PLANNING & ZONING CASE NO. SP2020-007

Project Name: 1480 Justin Rd.

RE: REVISION NARRATIVE – AMENDED SITE PLAN SUBMITTAL

SPR PACKAGING
OFFICE ADDITION
1480 JUSTIN RD., ROCKWALL, TEXAS

job no
1854
sheet
A1.0

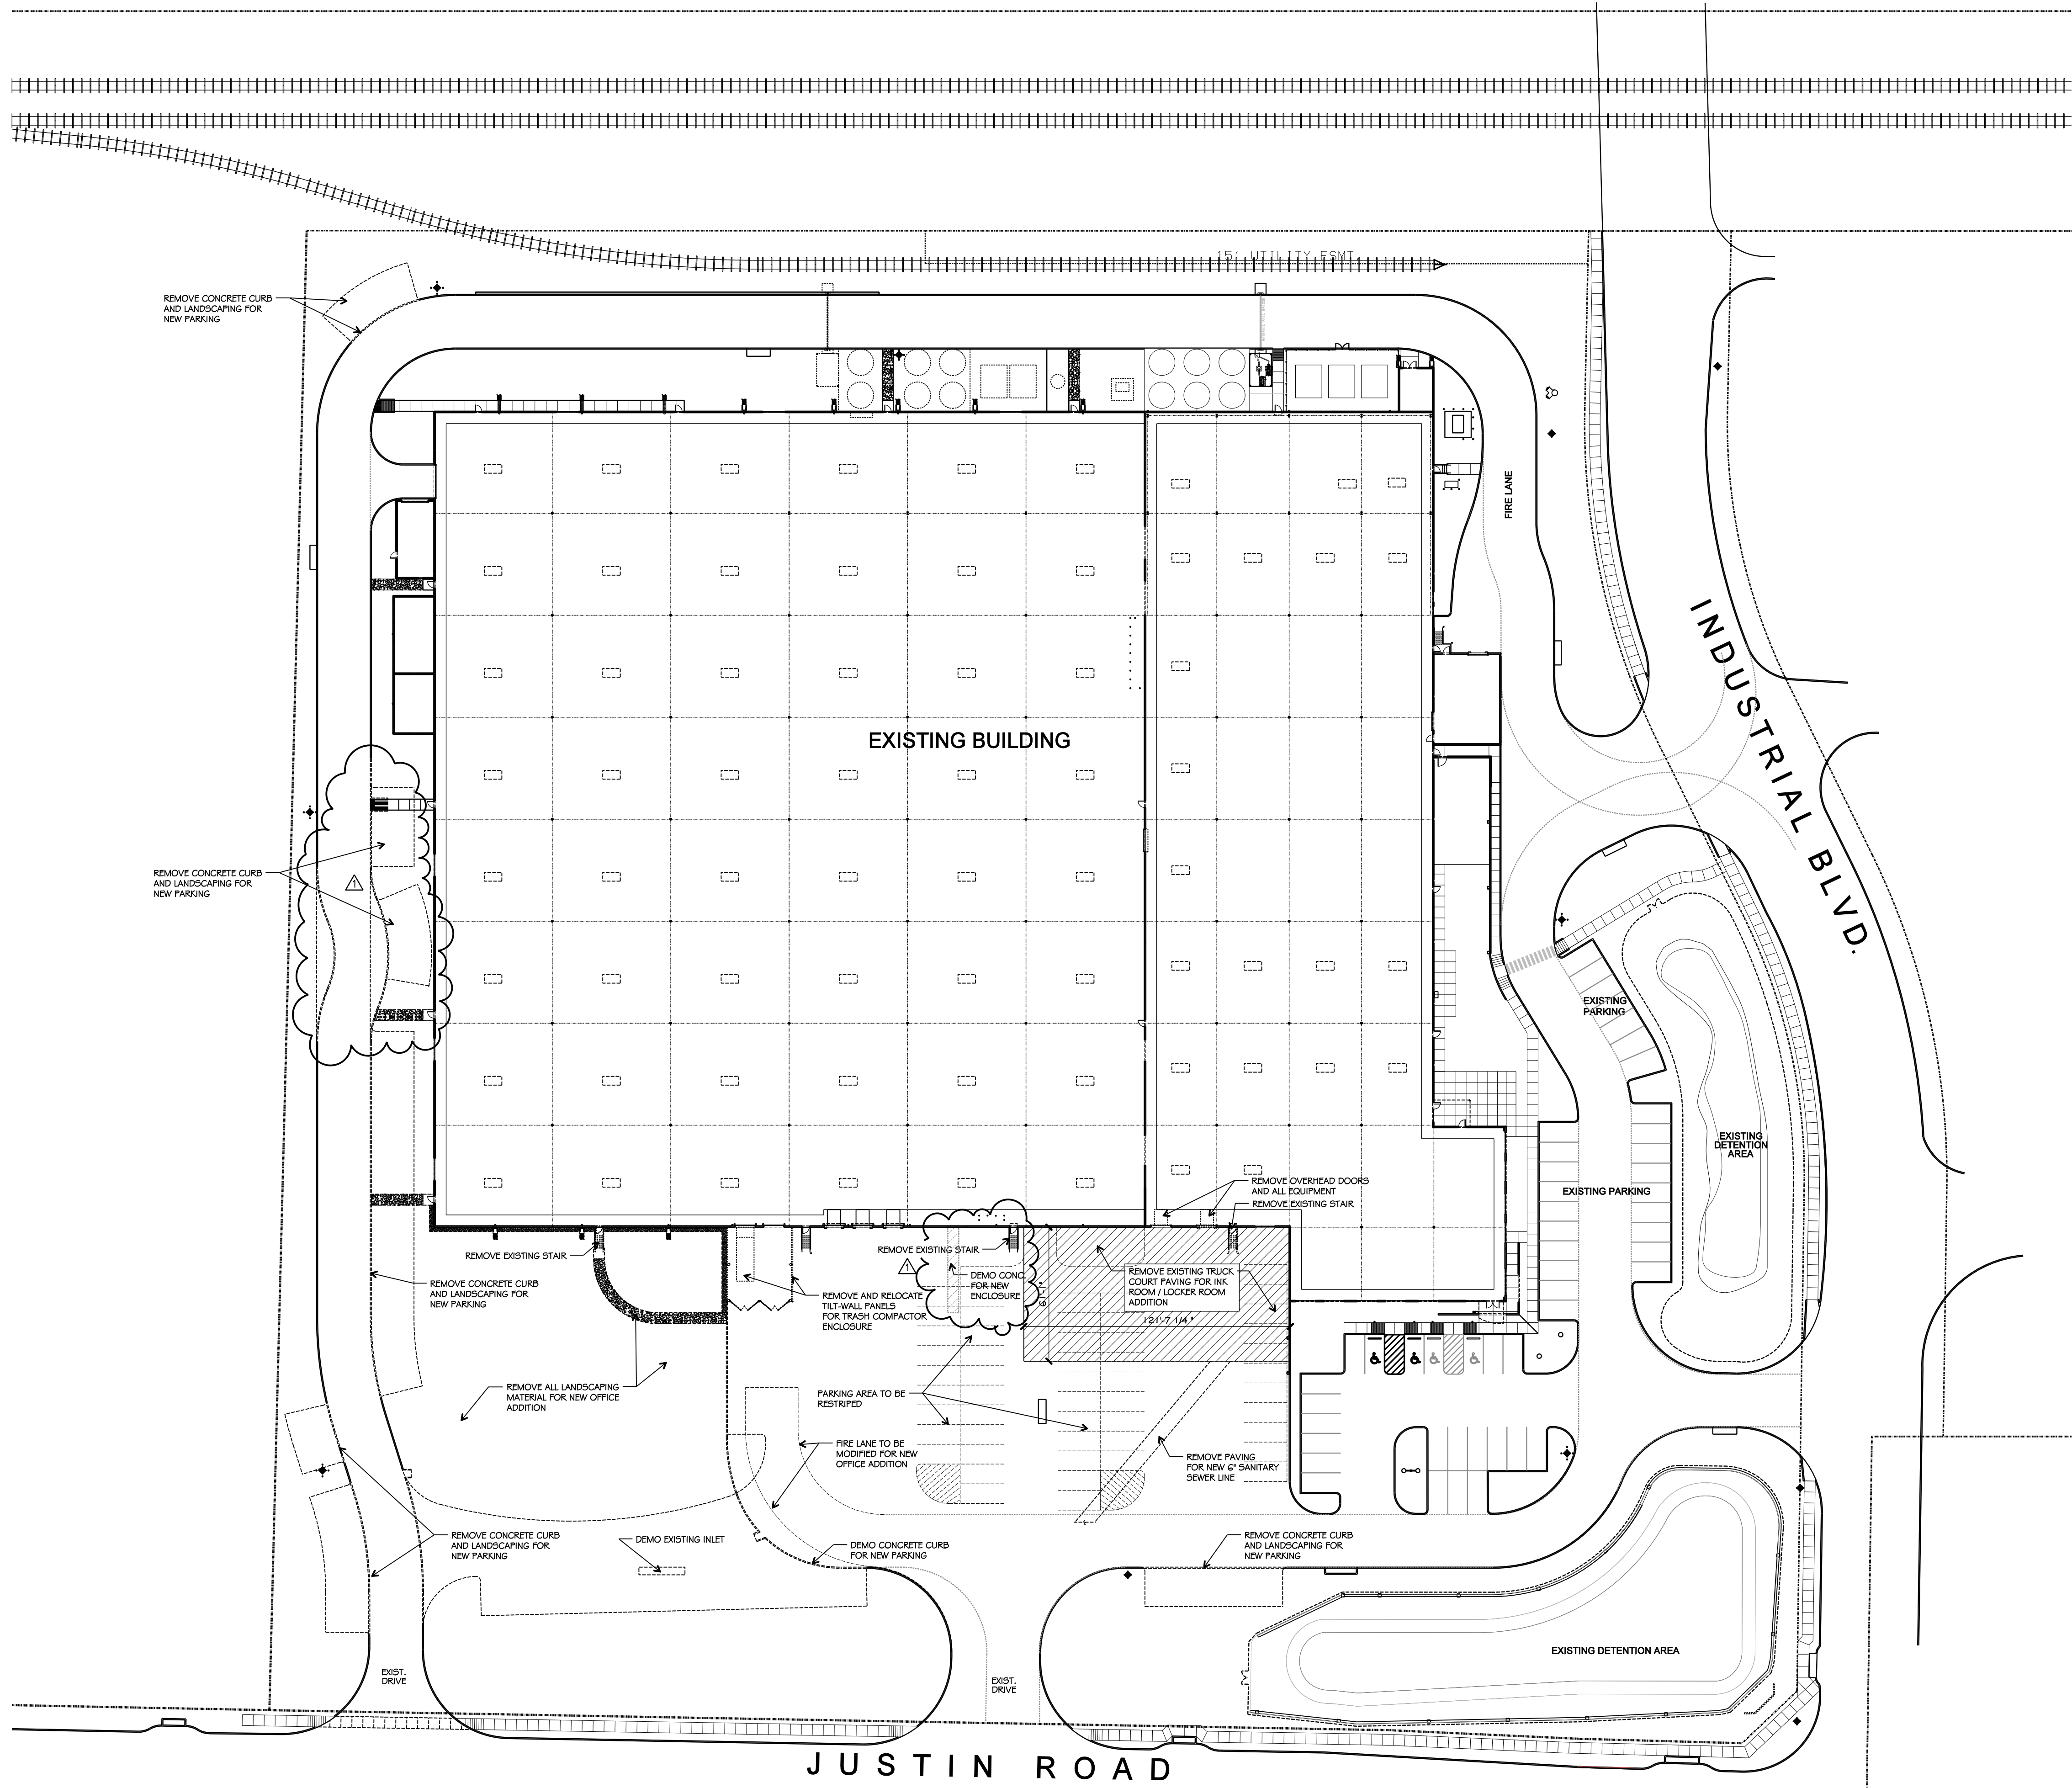
- The compactor enclosure has been moved further east and adjoined to the Ink Room addition exterior wall. The building wall will be protected by a traffic rated guardrail.
- Doors and stairs along the existing south wall have been relocated as needed to accommodate the new location of the compactor enclosure.
- At the existing west drive, the drive lane has been straightened with the Owner's removal of the existing 30" unprotected Bois d'Arc tree. Parking has been reconfigured to add three additional spaces to the site.
- Parking data is updated to reflect the additional parking spaces and the actual number of parking spaces added with the office and ink room additions.

job no
1854
sheet
A1.1

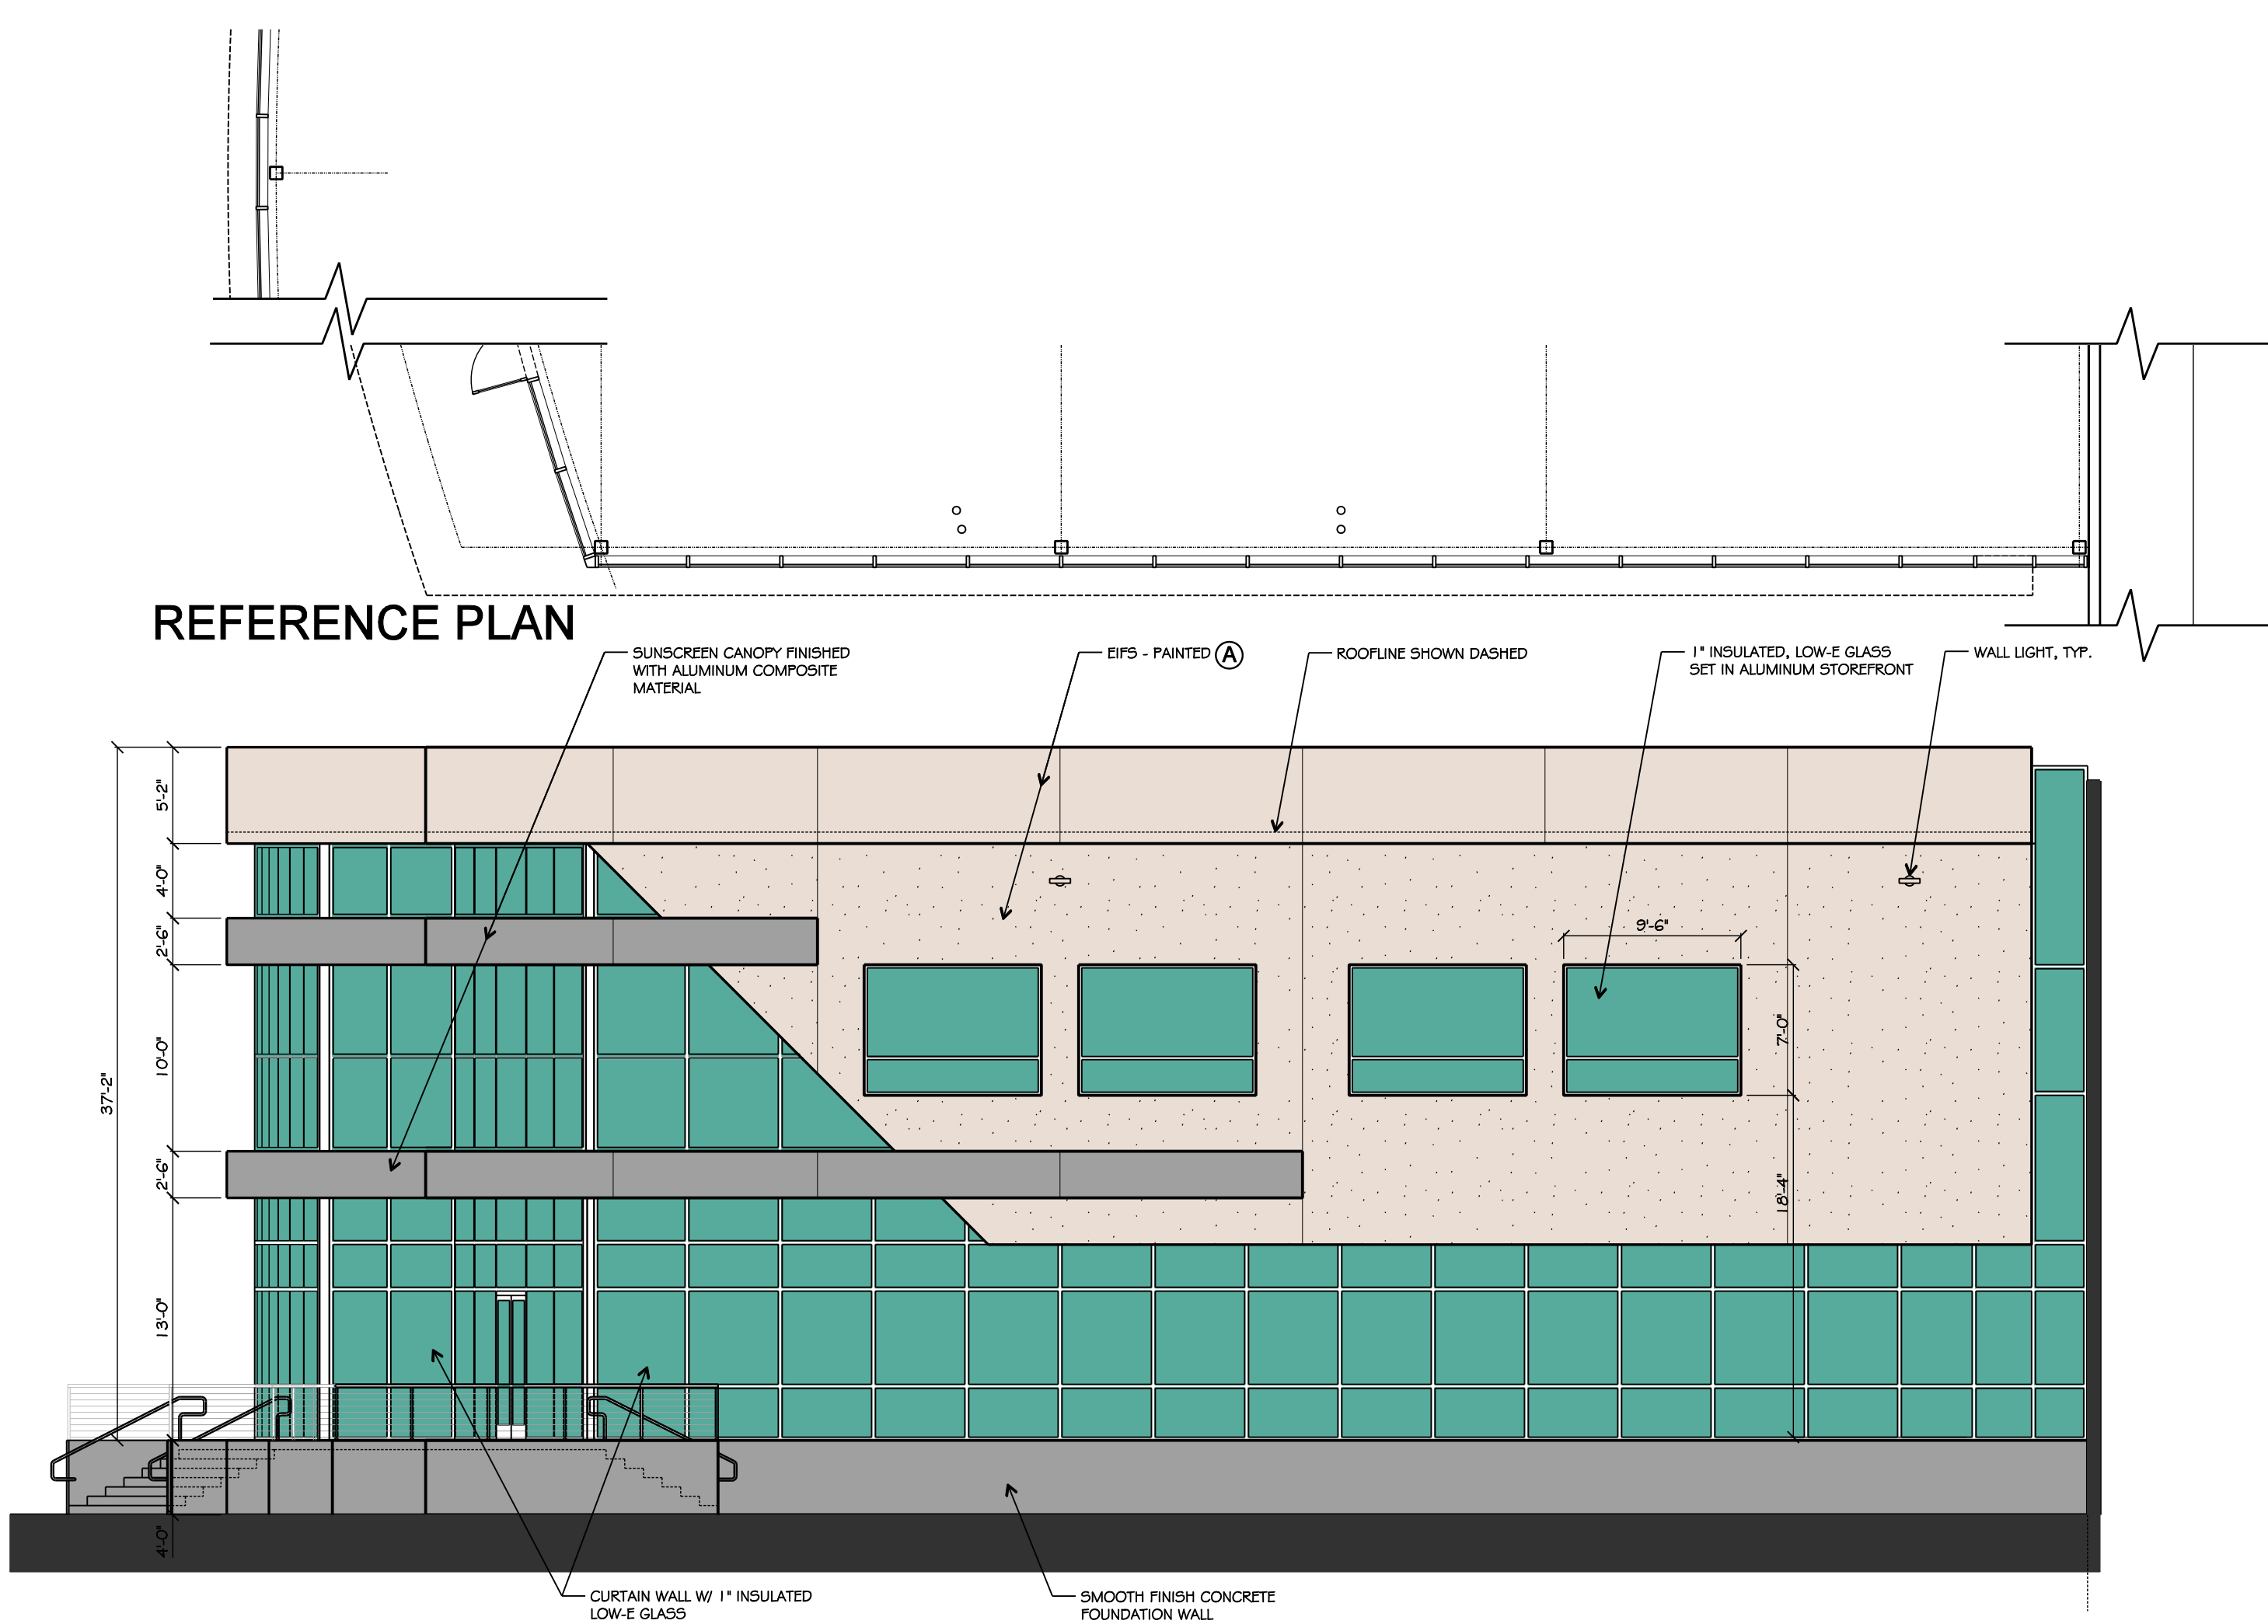
A1.1 Demolition / Existing Site Plan

1 SOUTH ELEVATION
SCALE: 1/8"=1'-0" FACES JUSTIN RD.

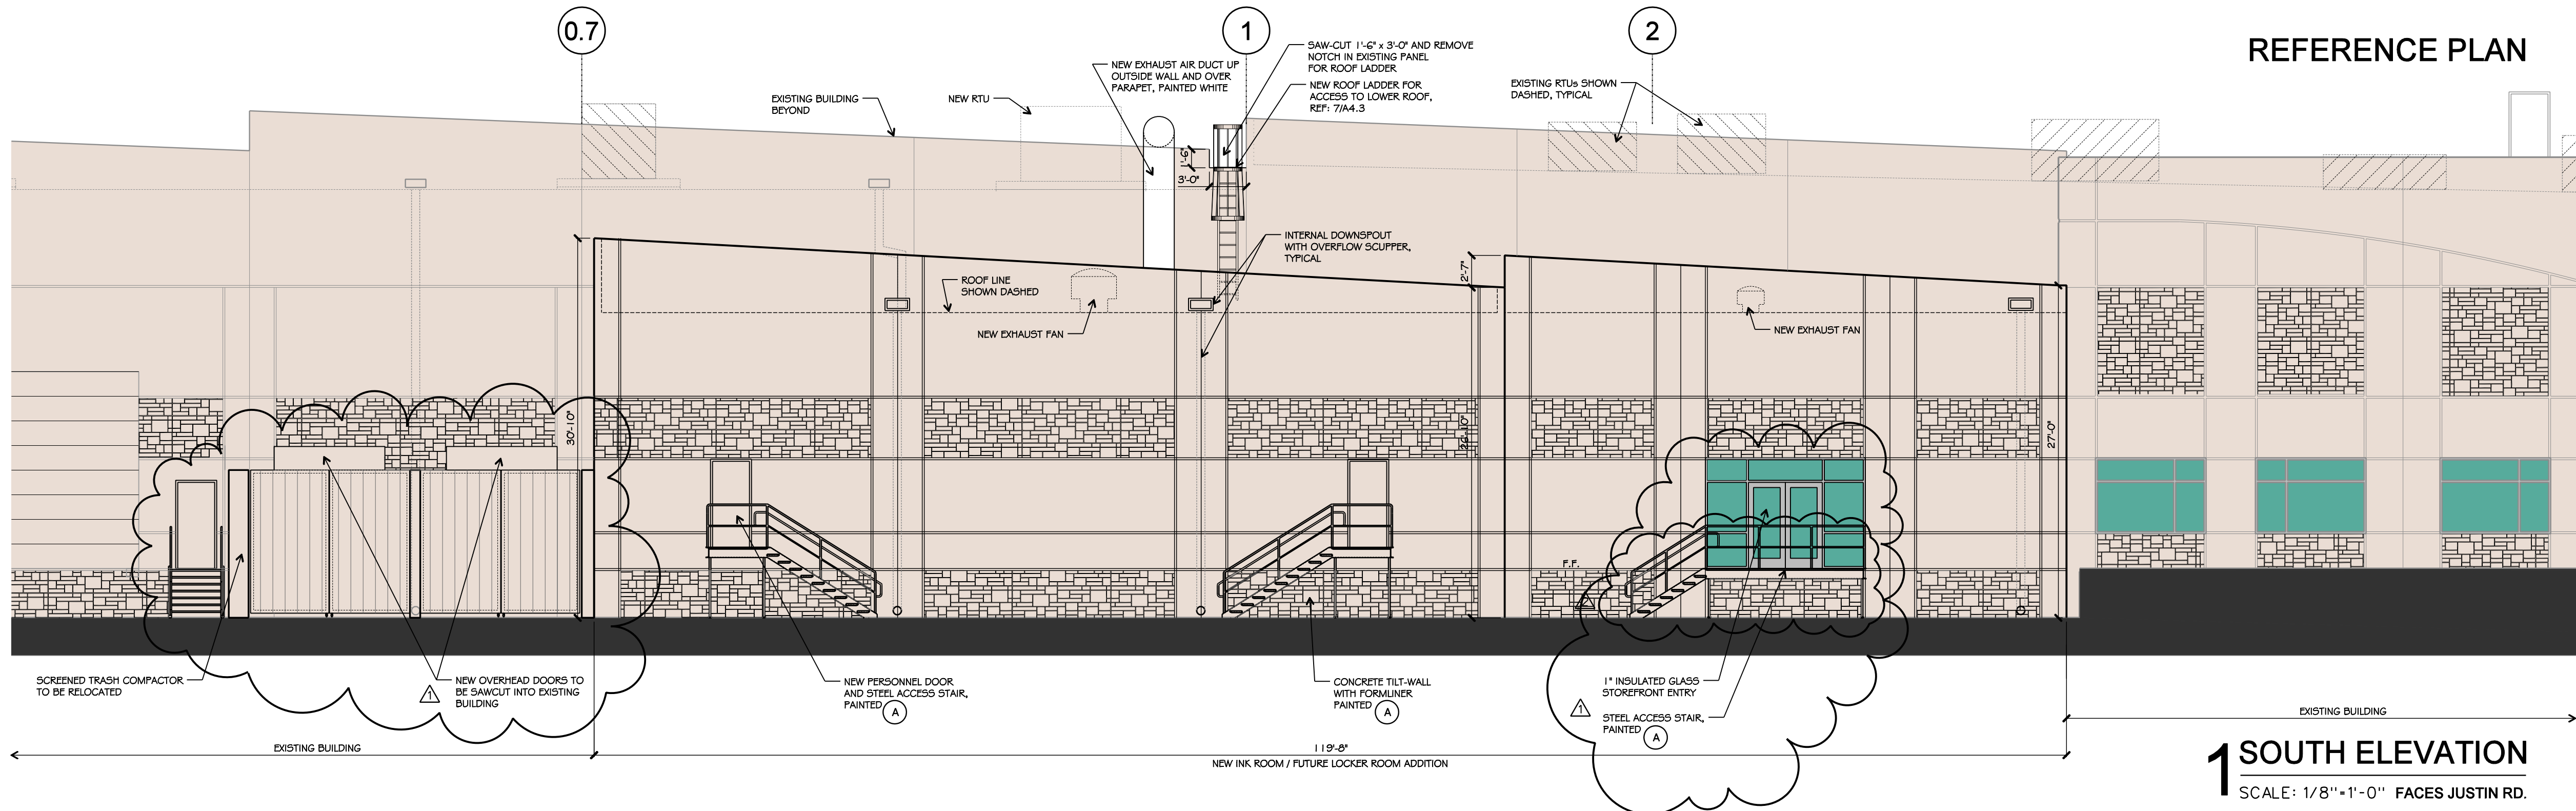
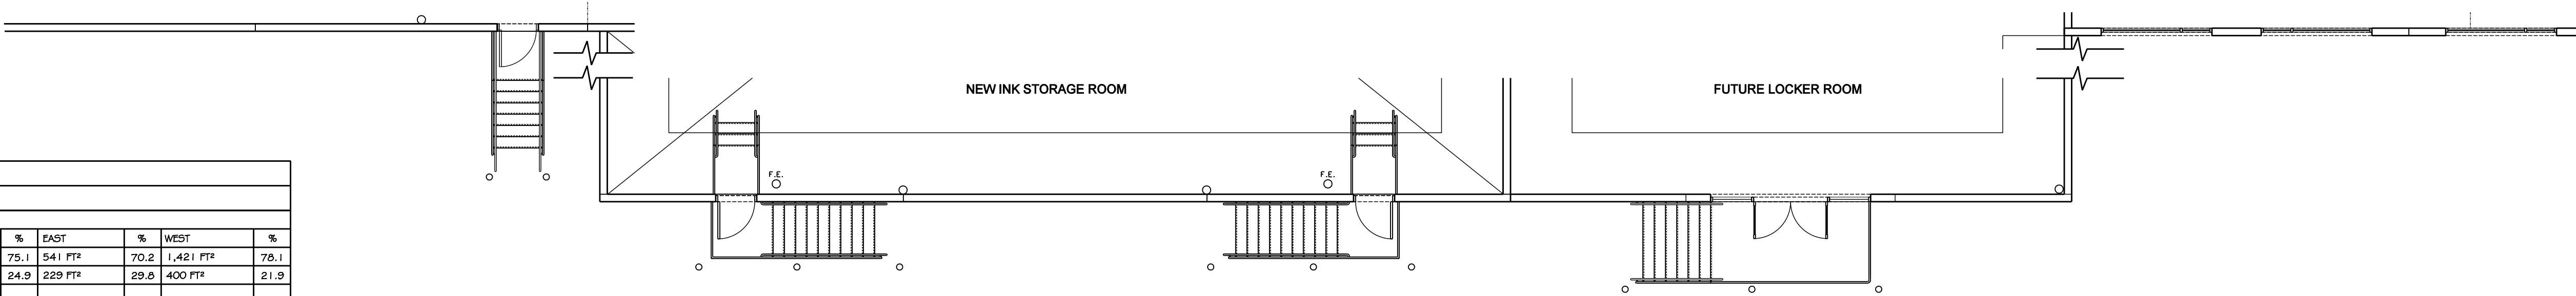
- Elevations are revised to show the new location of the compactor enclosure and the correct depiction of the entry stairs to the future locker room portion.
